Notice of Project Change

THE HUB ON CAUSEWAY

OFFICE TOWER

February 2018

LEGEND

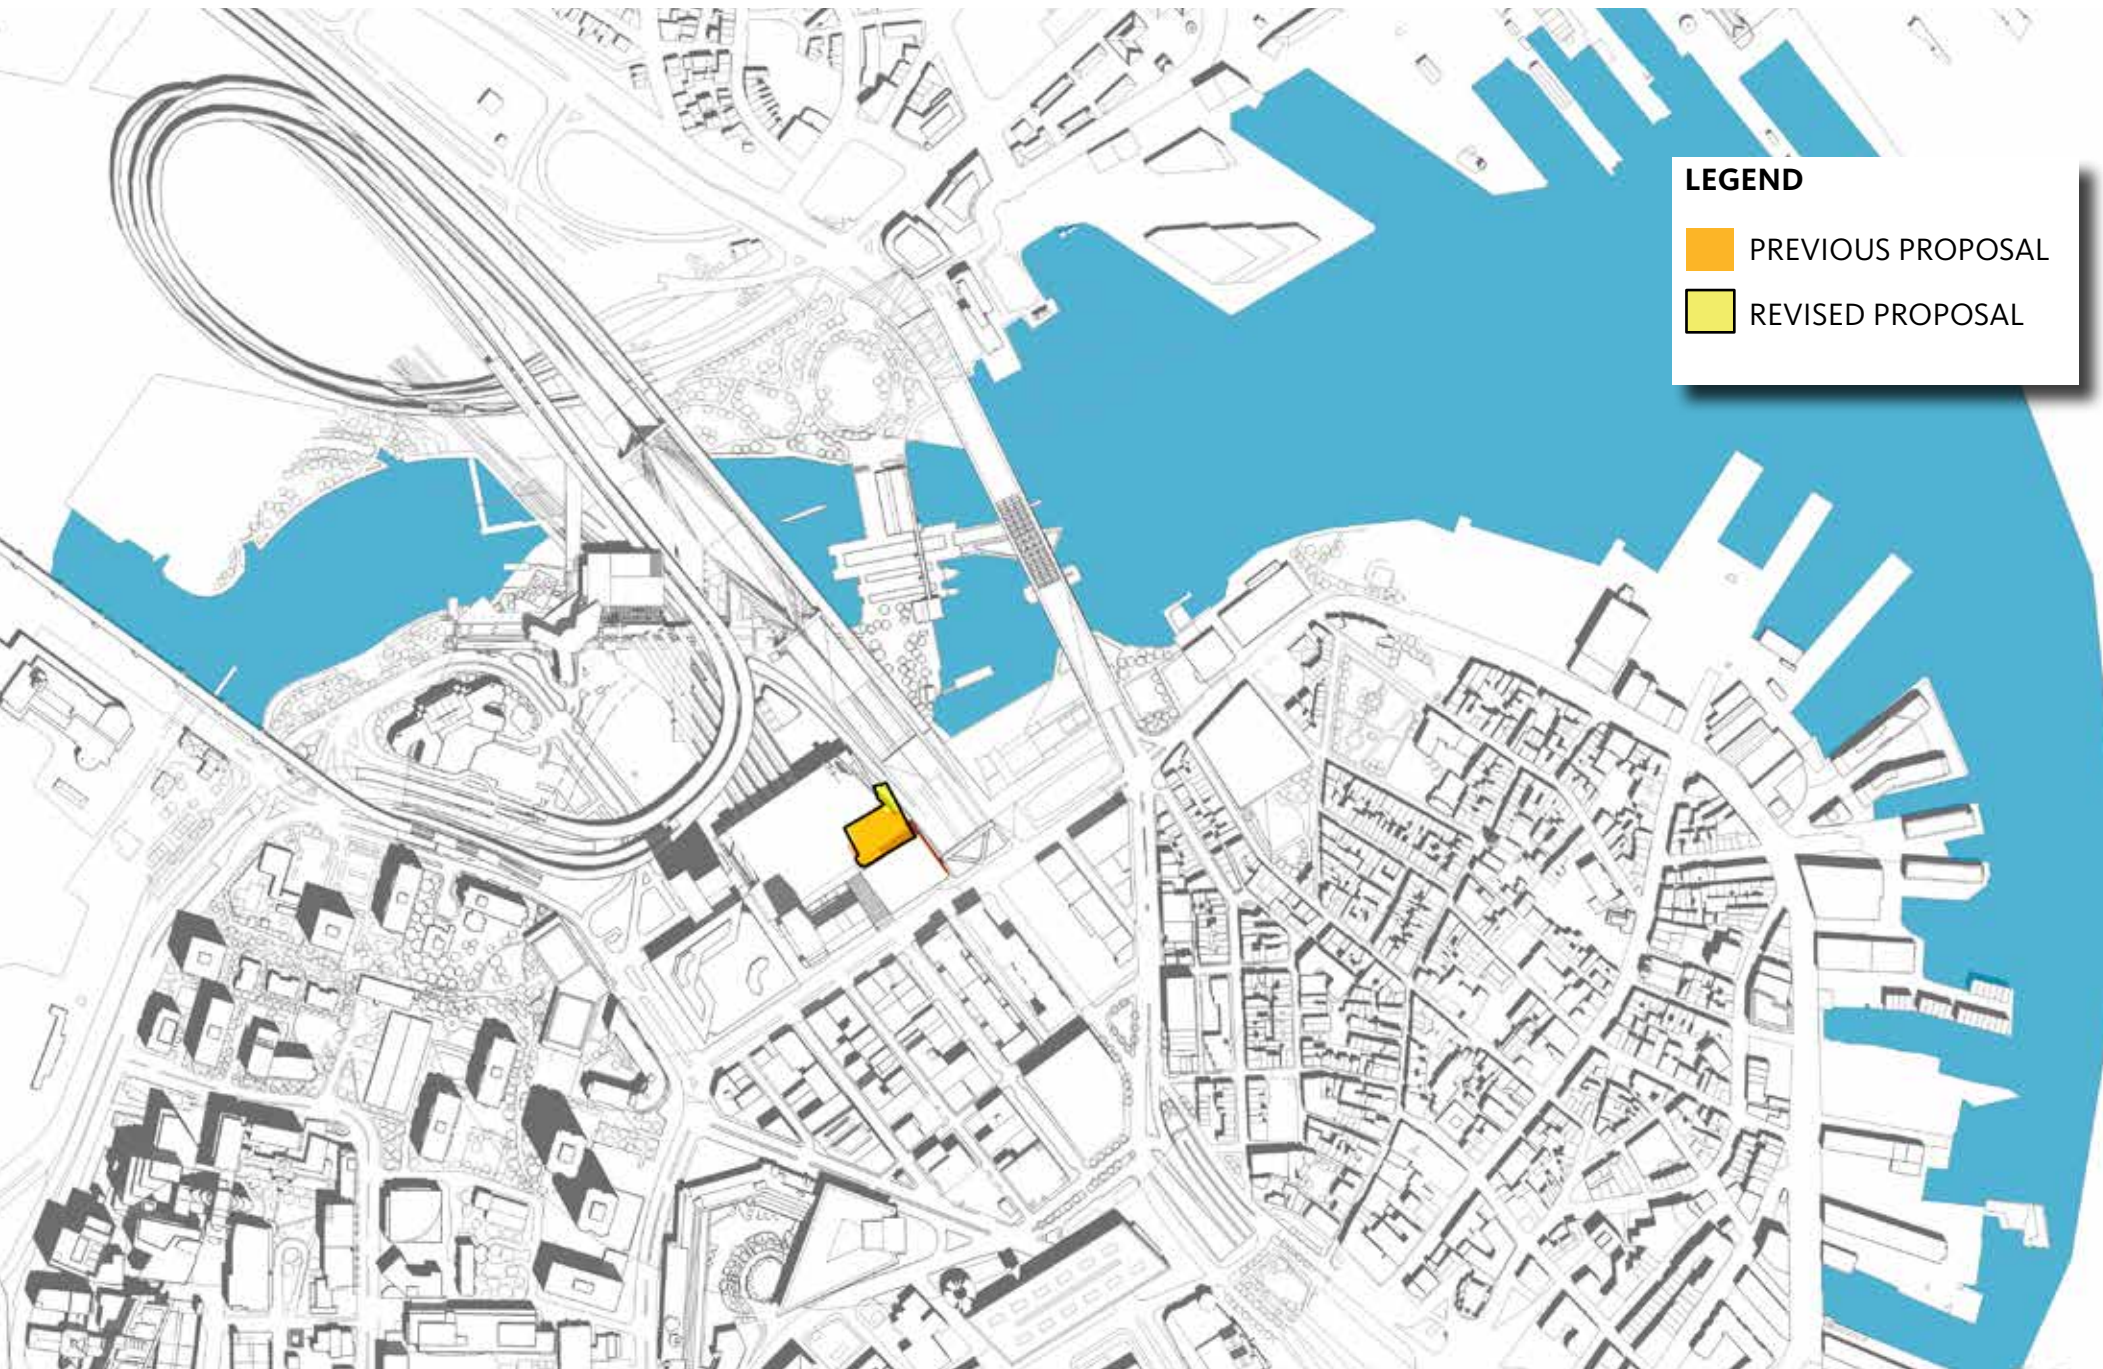
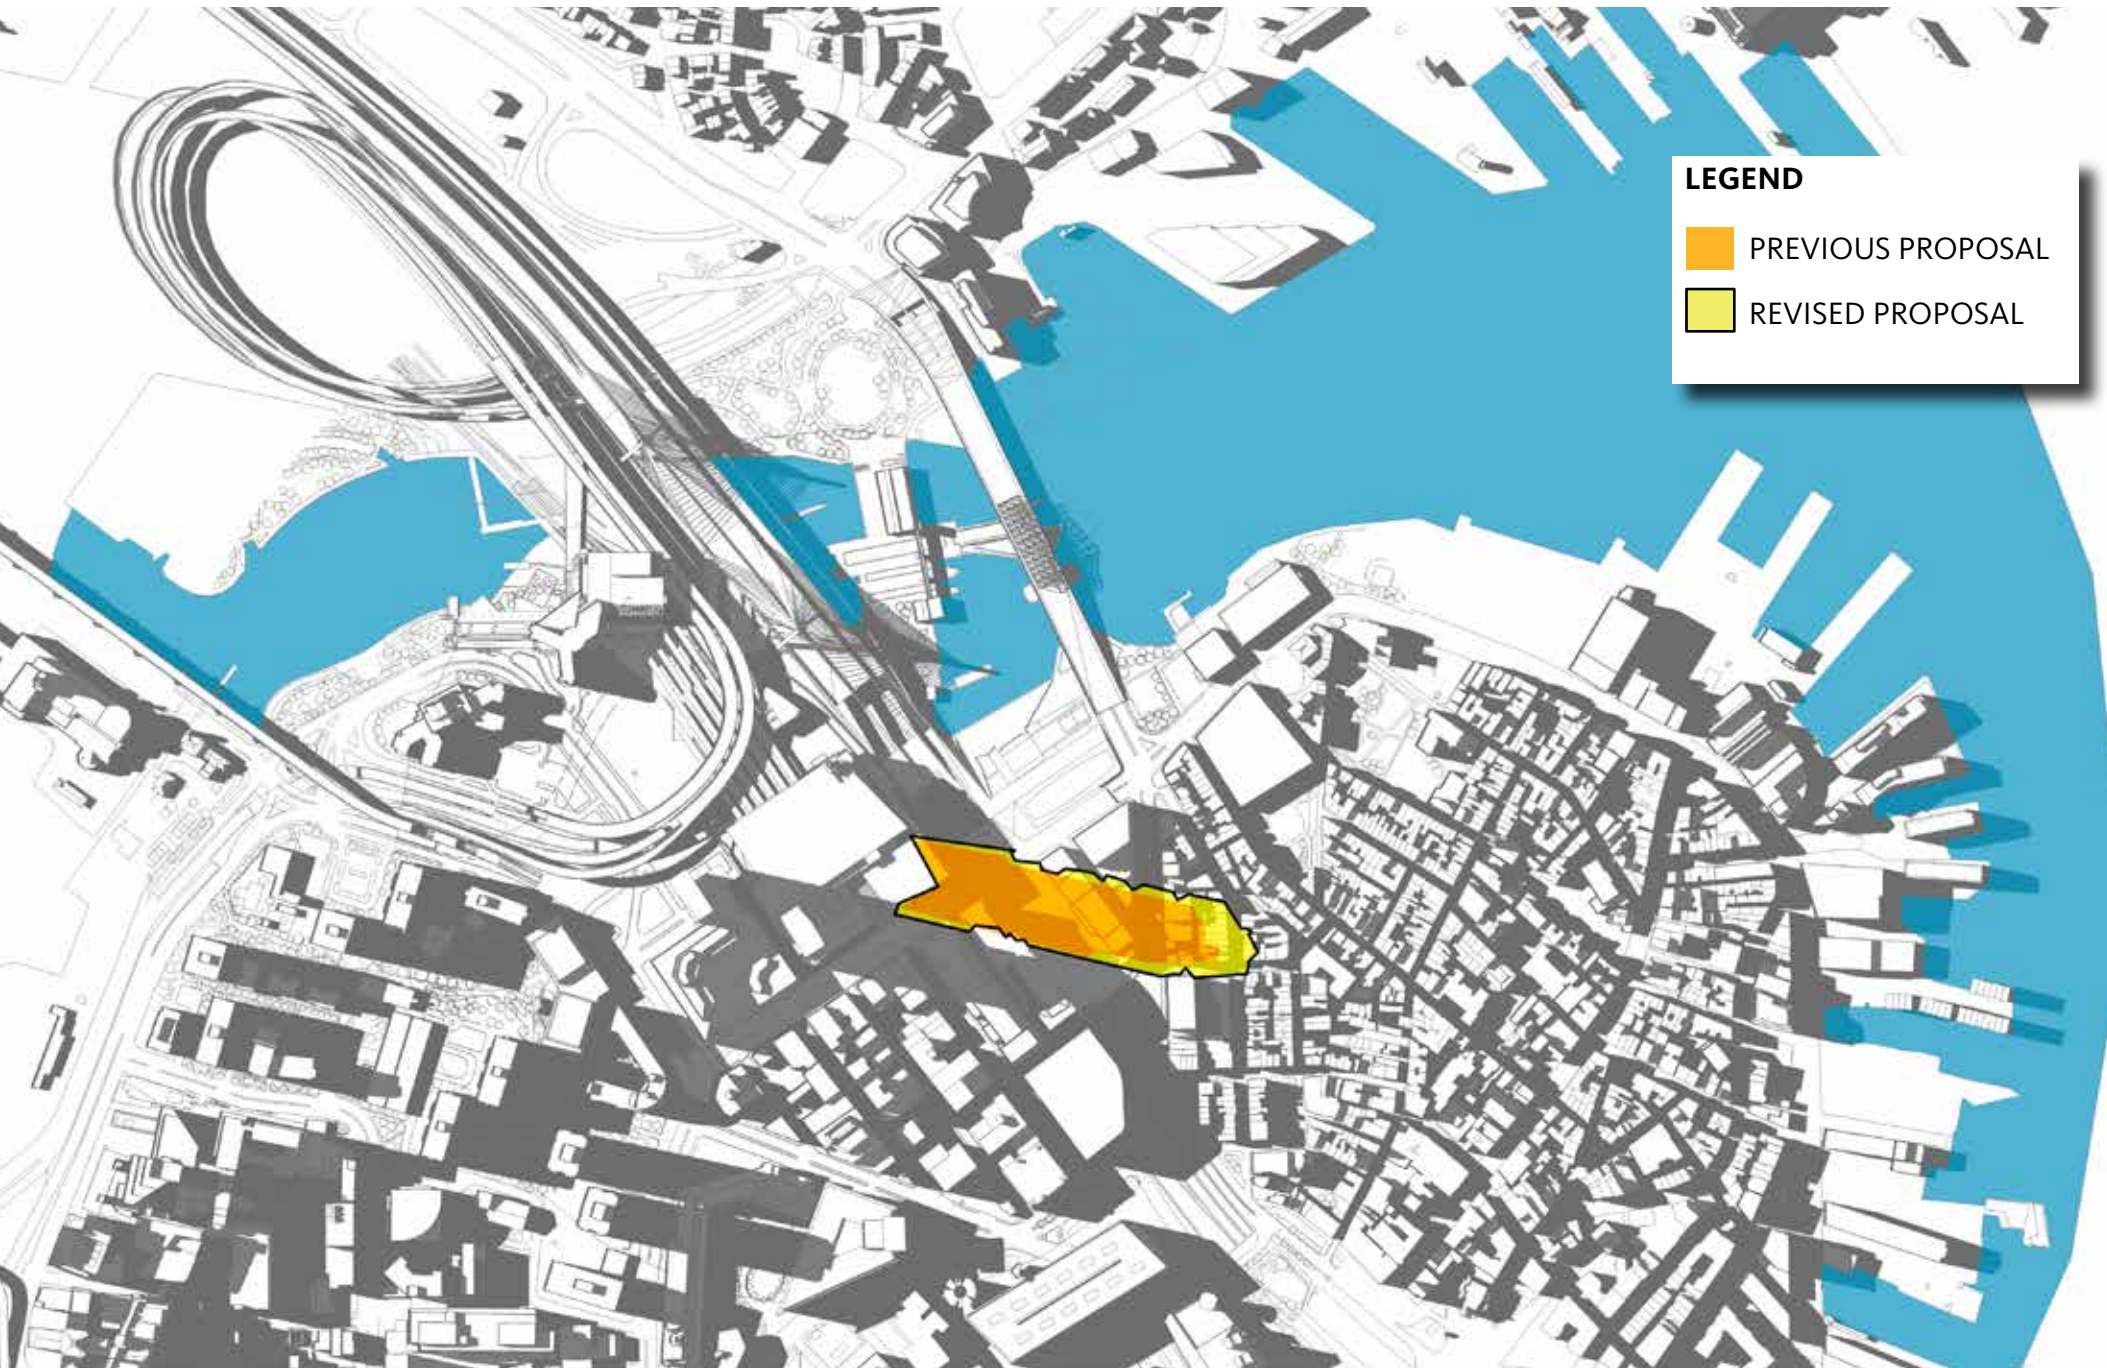
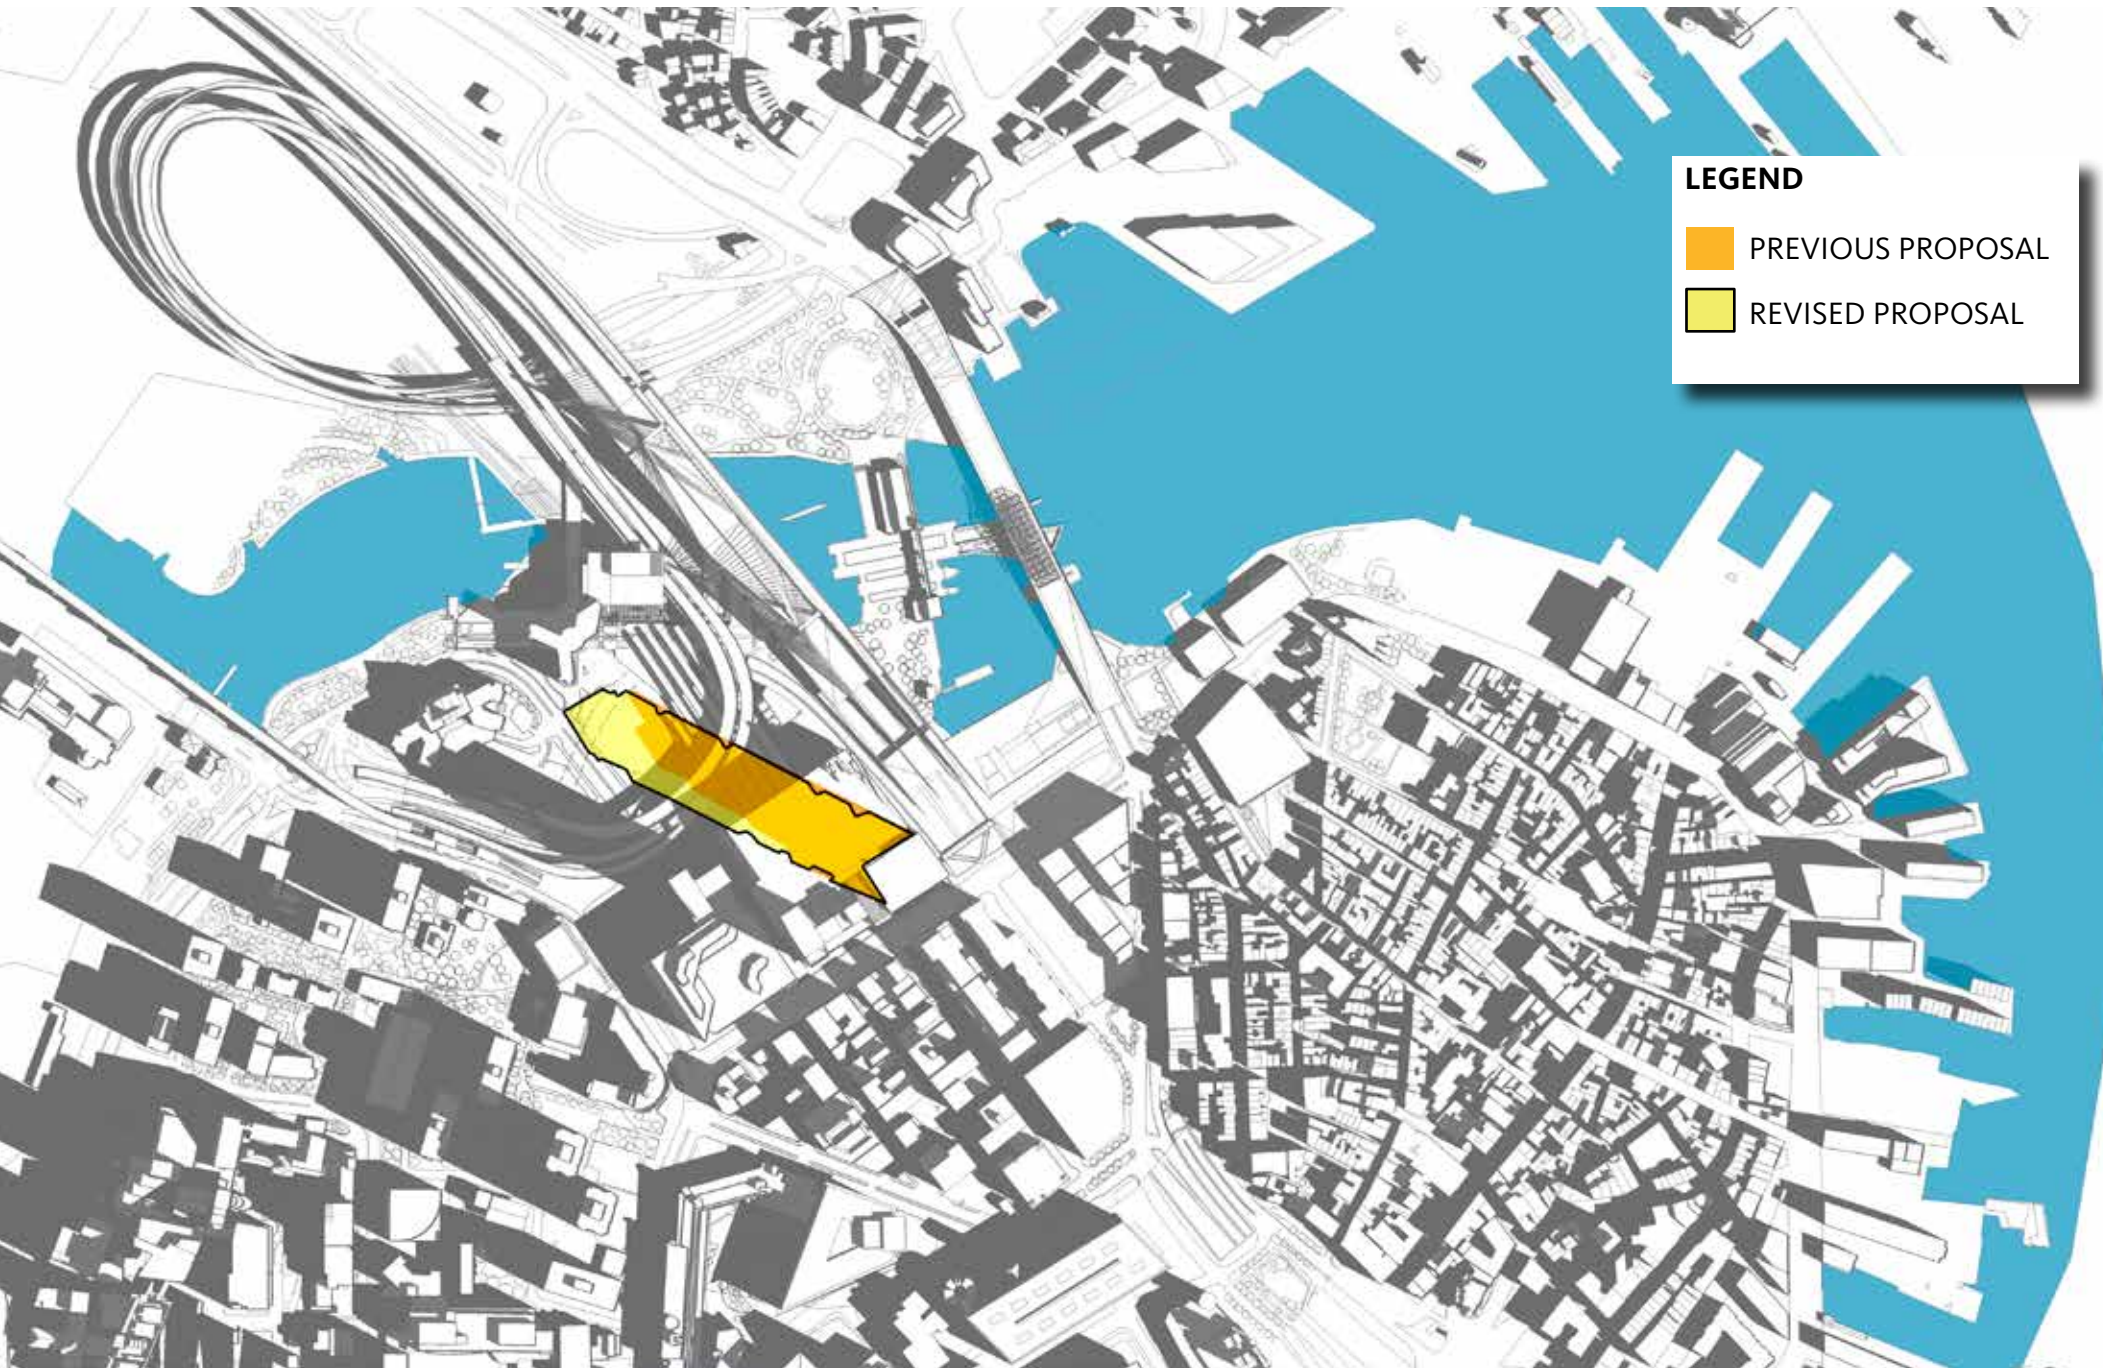
The new proposed Office Tower height of up to 495 feet is measured to the top of the highest occupiable floor. With the inclusion of an occupiable roof deck in the improved Office Tower design, the top floor (which previously was limited to mechanical equipment and was therefore excludable from the height calculation) is now included in height. This design change added approximately 30 feet to the height calculation for the Office Tower, without actually increasing

the physical height of the building. Overall, with the higher floor to ceiling expanses and the addition of one floor, the physical height of the Office Tower would be increased by about 45 feet (note: height calculated pursuant to the Boston Zoning Code would increase by approximately 75 feet). The increase in actual height, along with the expanded maximum floor plates, would result in a small extension of shadow, particularly during early morning, early evening and wintertime, when sun angles are low. Much of the additional shadow falls on areas such as the train tracks or areas already in shadow from other buildings. The updated Shadows Studies from the previous PNF Supplemental Information submittal dated December 6, 2013 (See Figures 4.B.1 through 4.B.13) show the previous Office Tower shadows in orange, with the proposed building shadow outlined and infilled with yellow. Changes in shadow are due in part to the different height, massing, positioning and orientation of the Office Tower on the Podium, and as mentioned above, are most differentiated when sun angles are low.
